Office Action Summary

DETAILED ACTION

1. The drawing amendment filed May 17, 2007 is not approved and is objected to under 35 U.S.C. 132(a) because it introduces new matter into the disclosure. 35 U.S.C. 132(a) states that no amendment shall introduce new matter into the disclosure of the invention. The added material which is not supported by the original disclosure is as follows:

FIG. 7

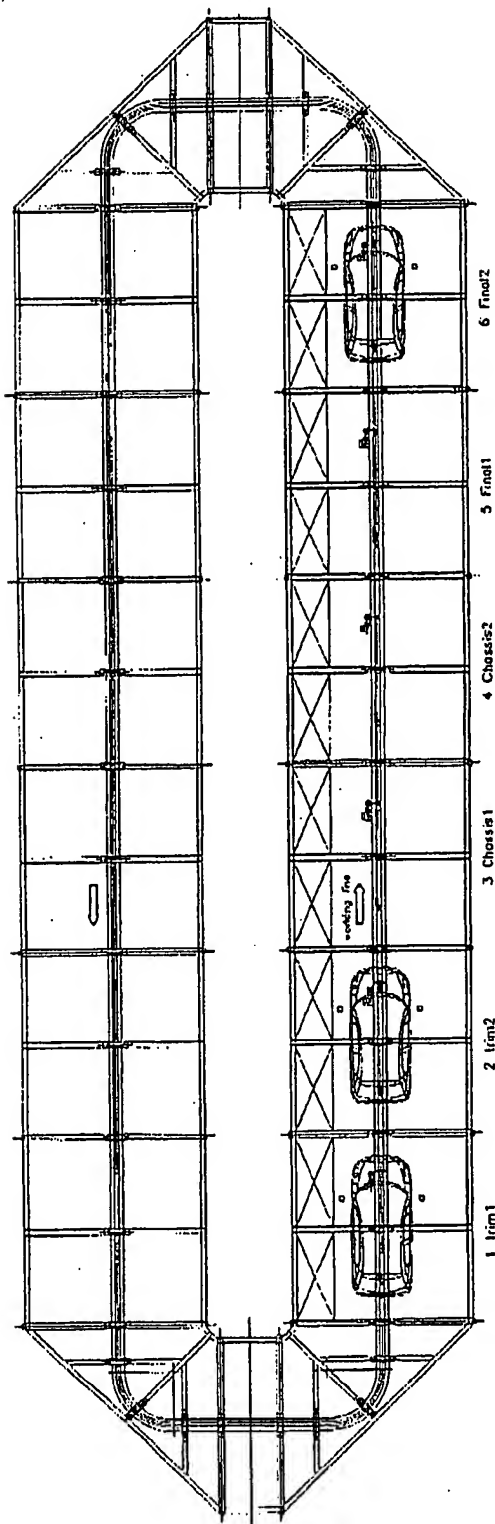
new Figures 7, 8a, 8b, 9, 10, 11a, 11b, 12a, 12b, 13a, 13b, 13c, 14a, 14b, and 14c all constitute new matter not supported by the original disclosure.

For example, with respect to new Figure 7, the specification as originally filed does not support the showing of a conveyor that is laid out/shaped as shown in Figure 7, nor does it support the showing of the specific stations labeled thereon, nor the showing of such in the order set forth in Figure 7, for example.

Not approved
EEC
8/1/07

Applicant is required to cancel the new matter in the reply to this Office Action.

FIG. 8b

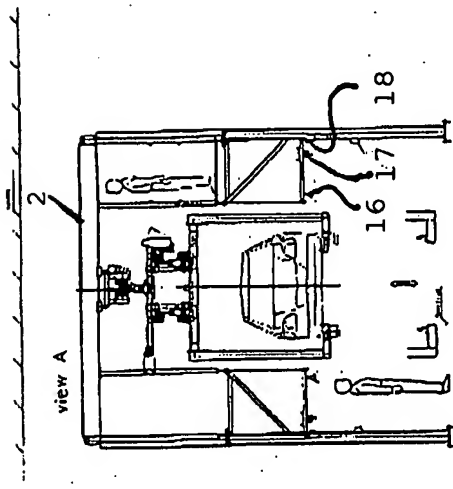
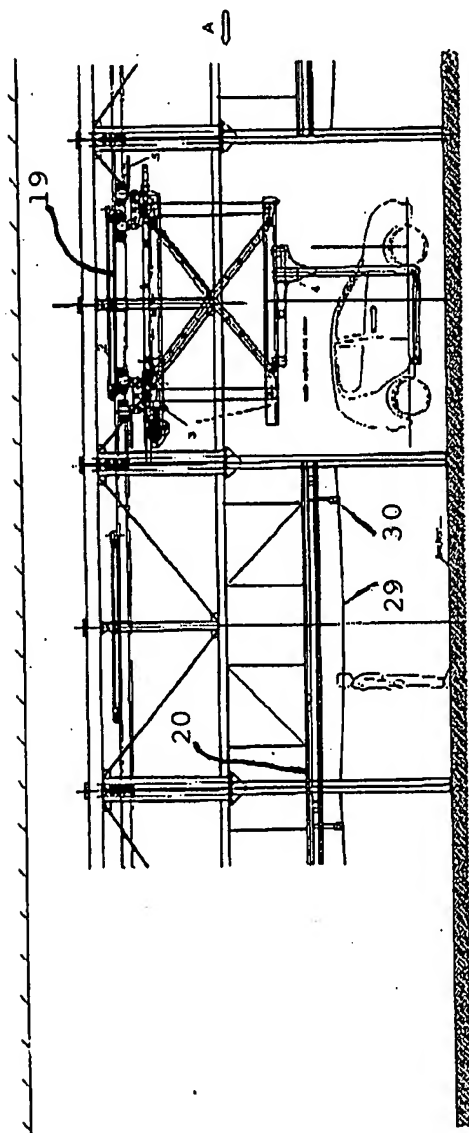
A similar situation exists for each of the newly-added figures. For example, it is noted that the specification as originally filed does not support the level of detail shown in Figures 8a and 8b, the particular configuration of "driven element" acting on a tire shown in new Figure 9, nor even the particular configuration of the tire shown in Figure 9, the particular configuration of the "motor-driven element" acting on a "wheel rim", nor the particular configuration of "wheel

Not
Approved
ECC
8/1/07

FIG. 9

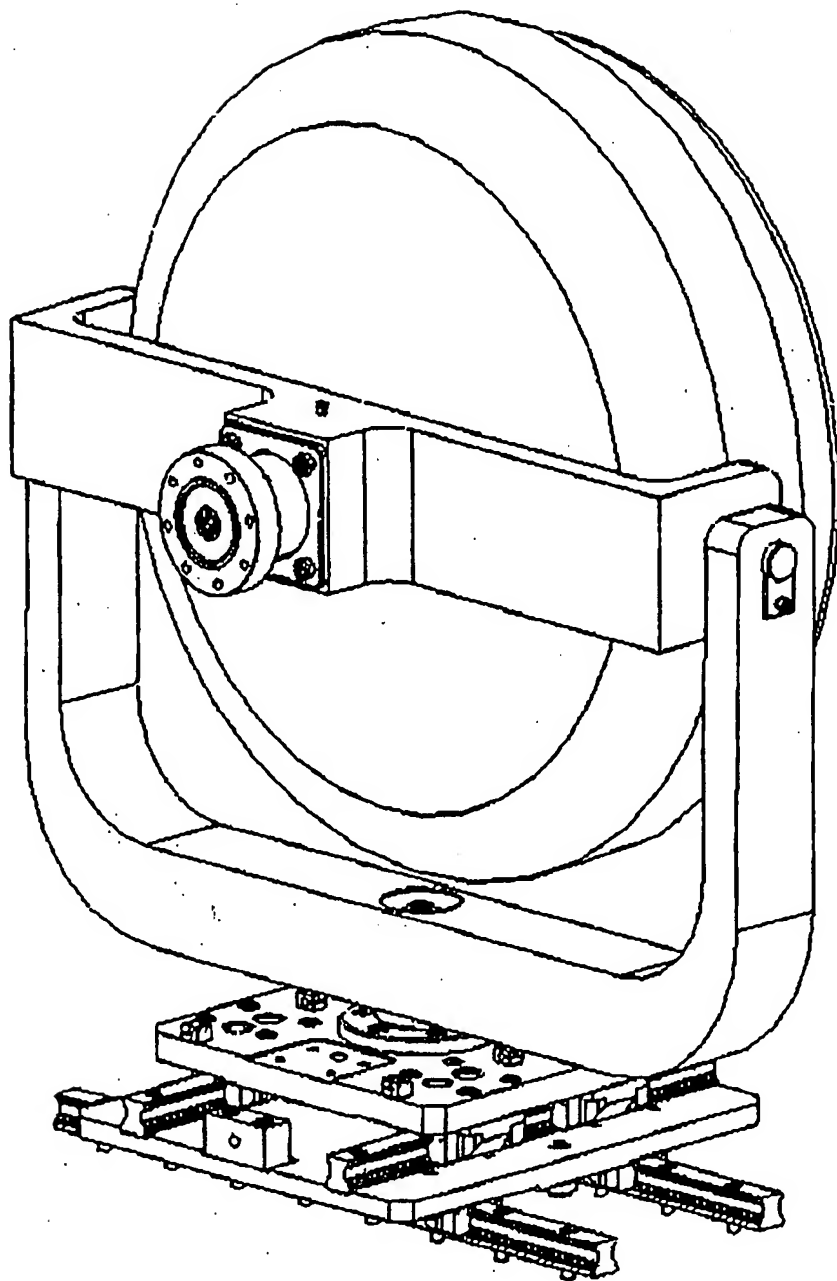
Not approved
EEC
8/1/07

FIG. 10

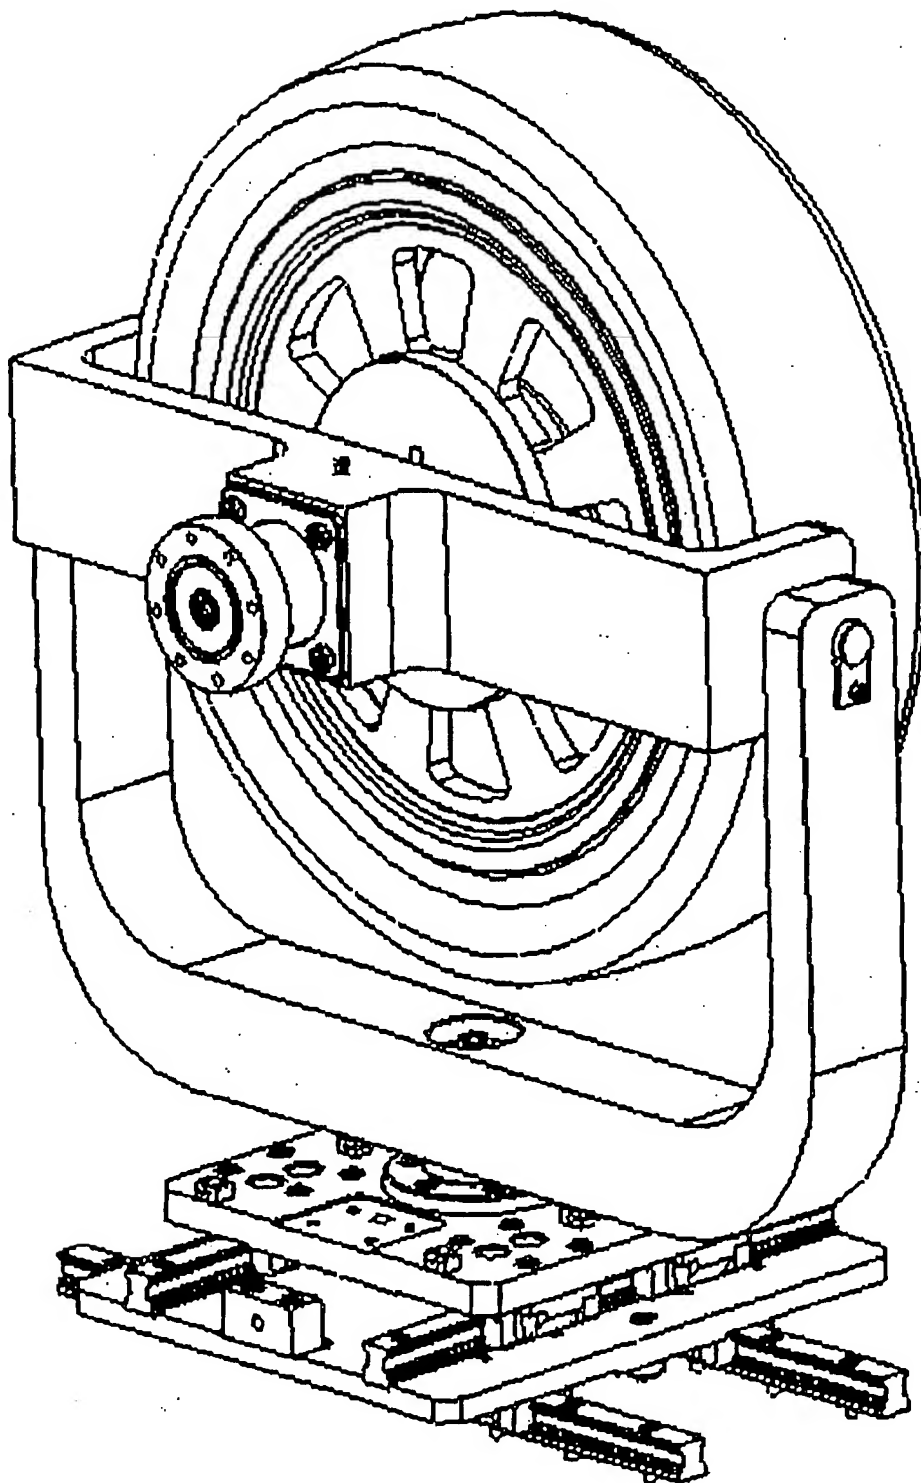
rim” shown in Figure 10, the particular configuration of “motor driven element” acting on a “wheel hub” shown in new Figure 11a, nor the particular configuration of “wheel hub” shown in new Figure 11a, the configuration of “motor vehicle element” shown in new Figure 11b, the particular configuration of a “means for automatically performing accelerating and braking operations” shown in new Figure 12a and 12b, nor the particular configuration of “tire” shown in new Figure 12a, the particular configuration of the “means for overhead conveyance” shown in new Figures 13a-13c (particularly noting that the configuration shown in new Figures 13a-c is of a different configuration than the overhead conveyance arrangement shown in the original figures, see at least original figures 2b and 3b, for example), and the particular configuration of “modular components that perform assembly” shown in new Figures 14a-14c.

Not Approved
EEC
8/1/07

FIG 11a

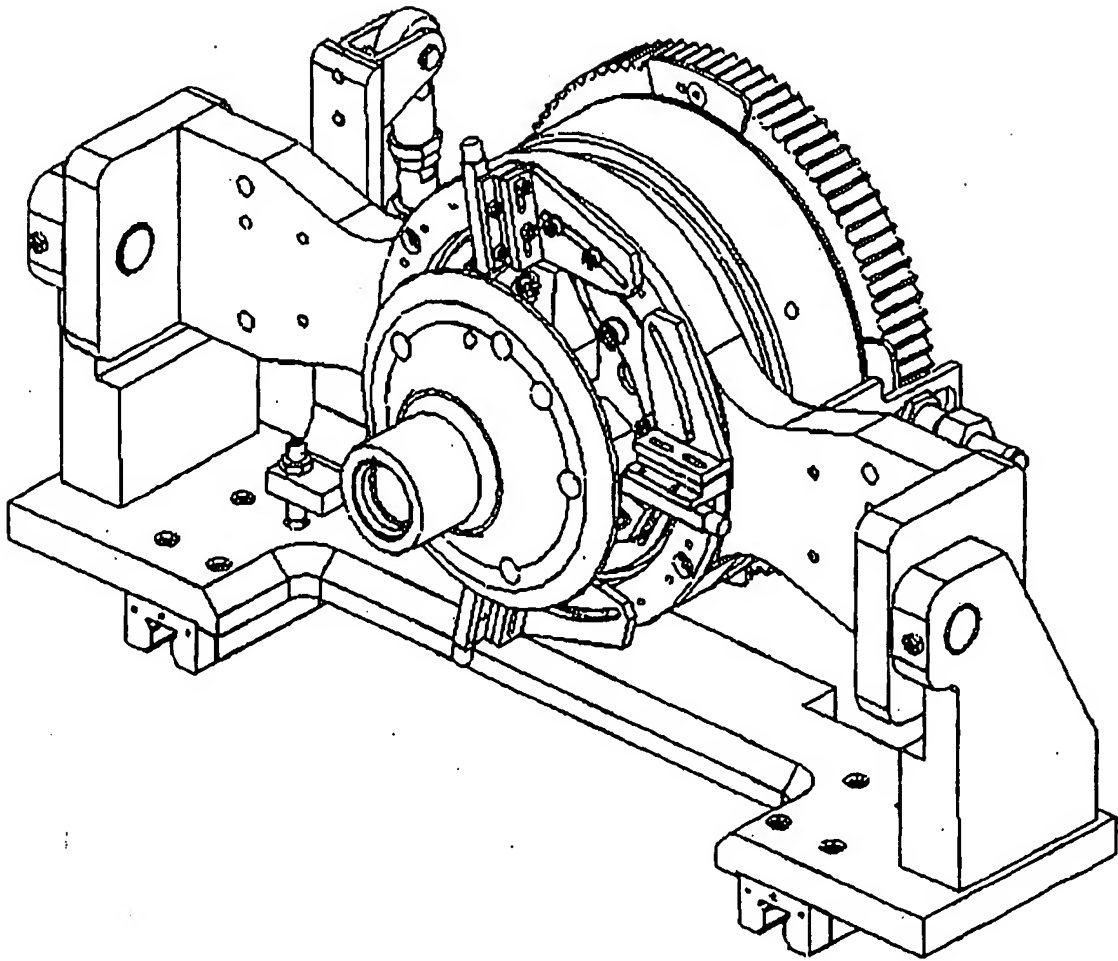
Not Approved
8/1/07
GCL

FIG. 11b

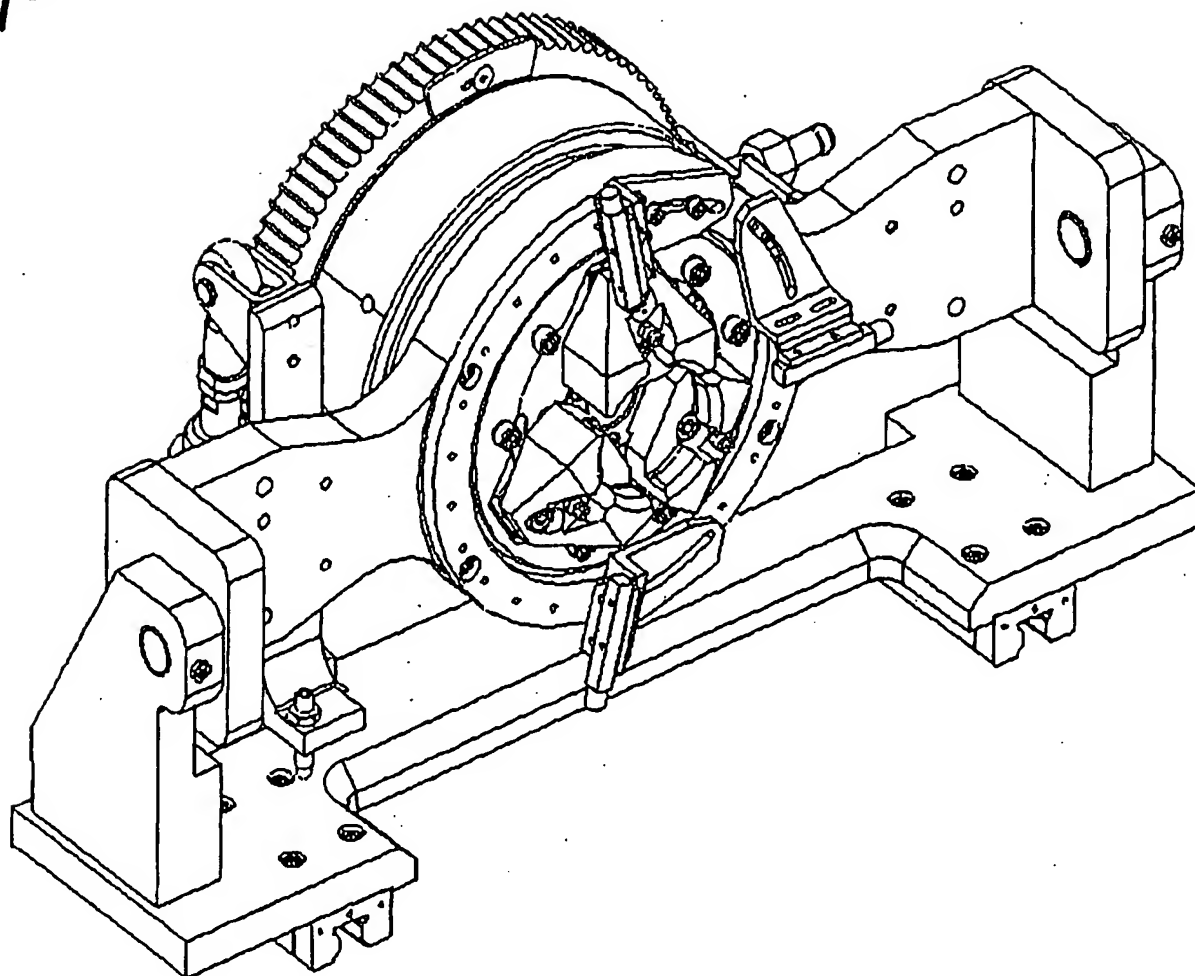
Not
approved
EEC
8/1/07

FIG. 12a

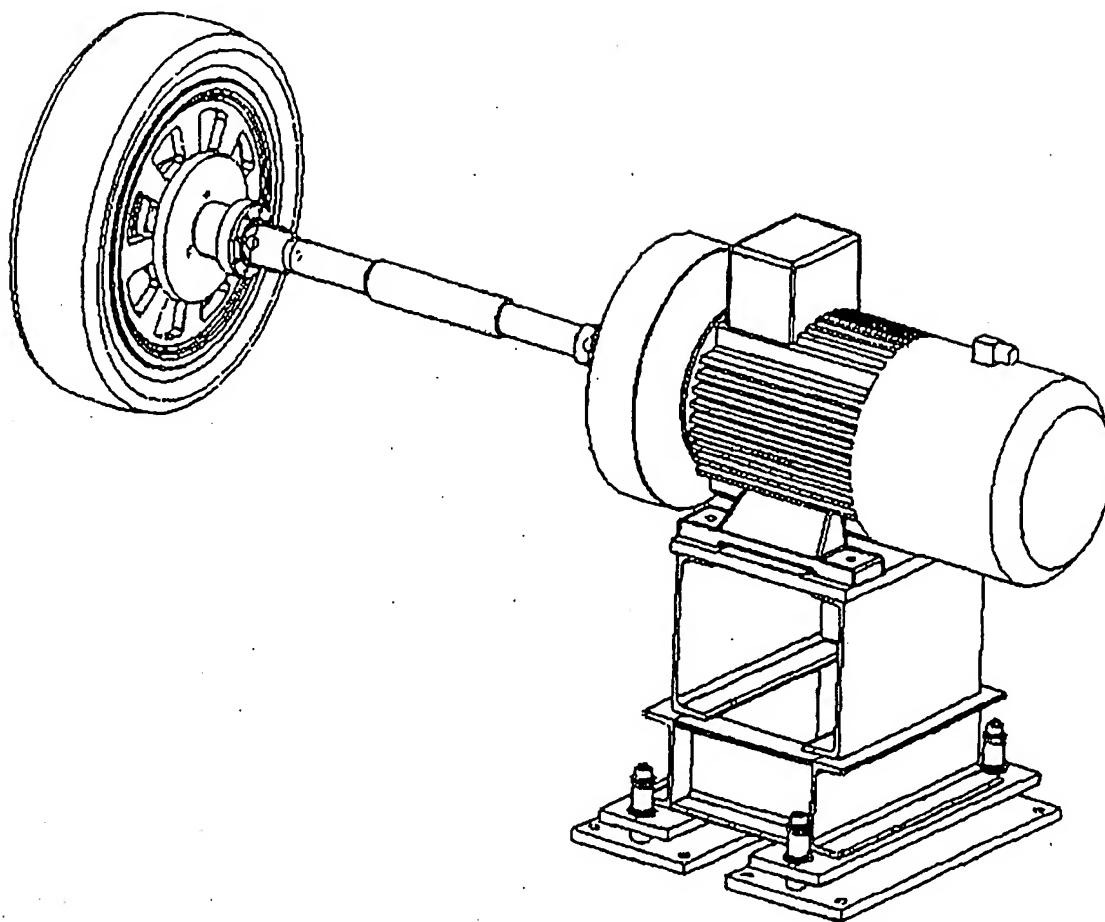
Not Approved
SEC
8/1/07

FIG. 12b

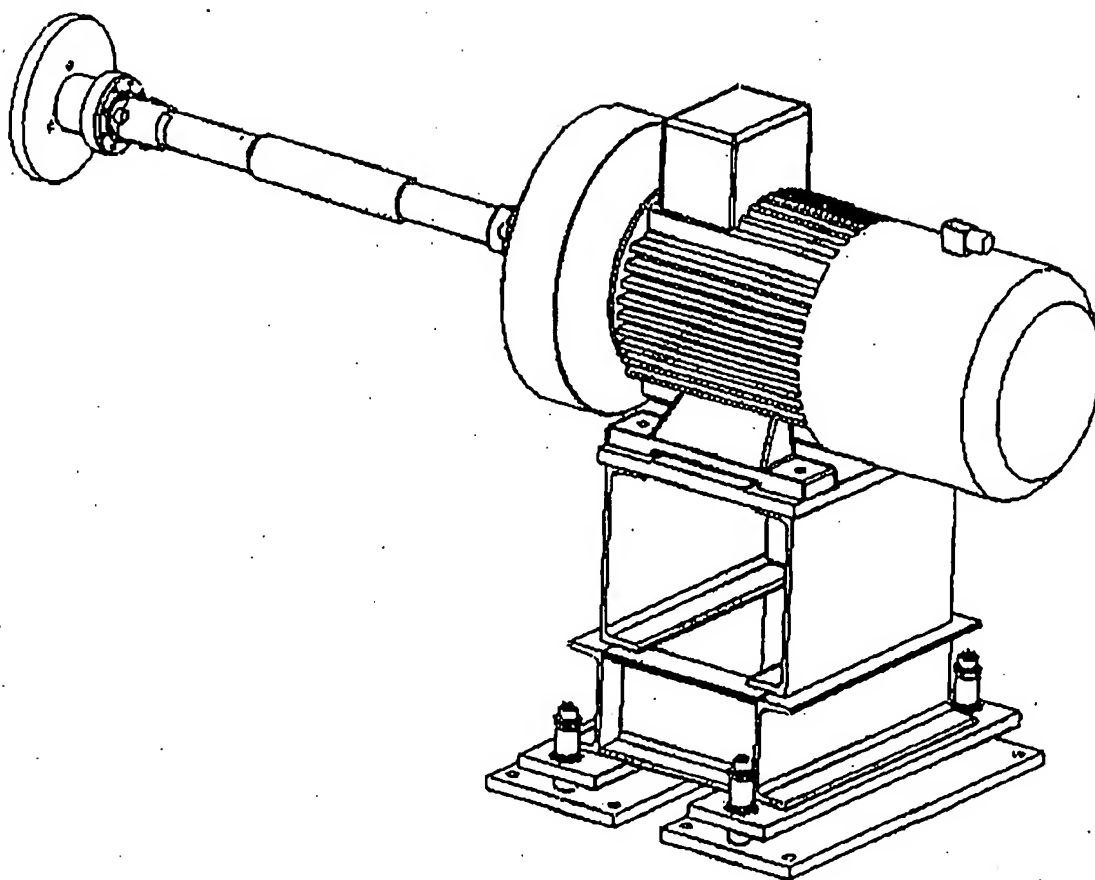
Not Approved
8/1/07
EGC

FIG. 13a

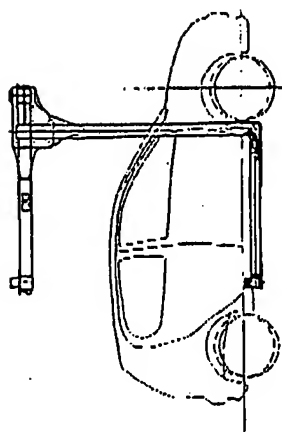
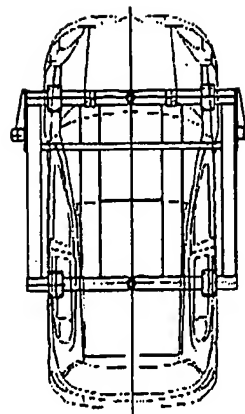
Not Approved
EEC
8/1/07

FIG 14a

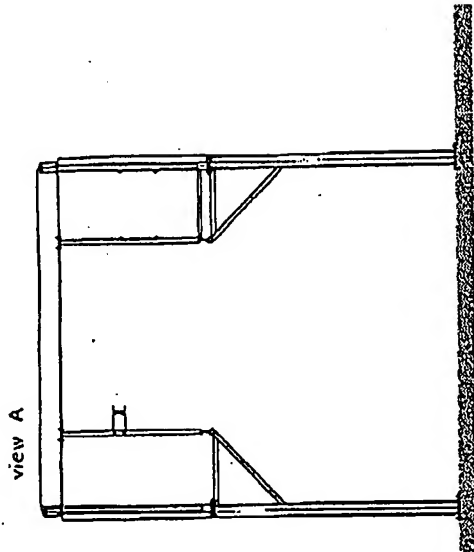
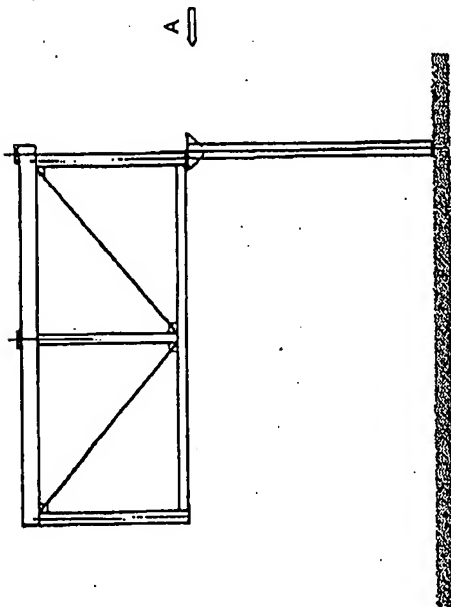
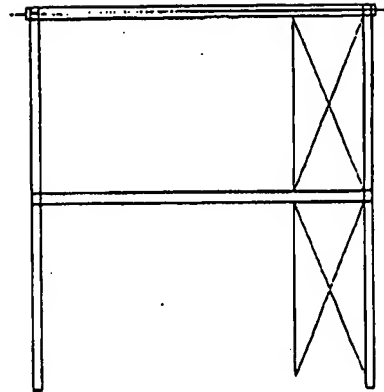
Not approved
EEC
8/1/07
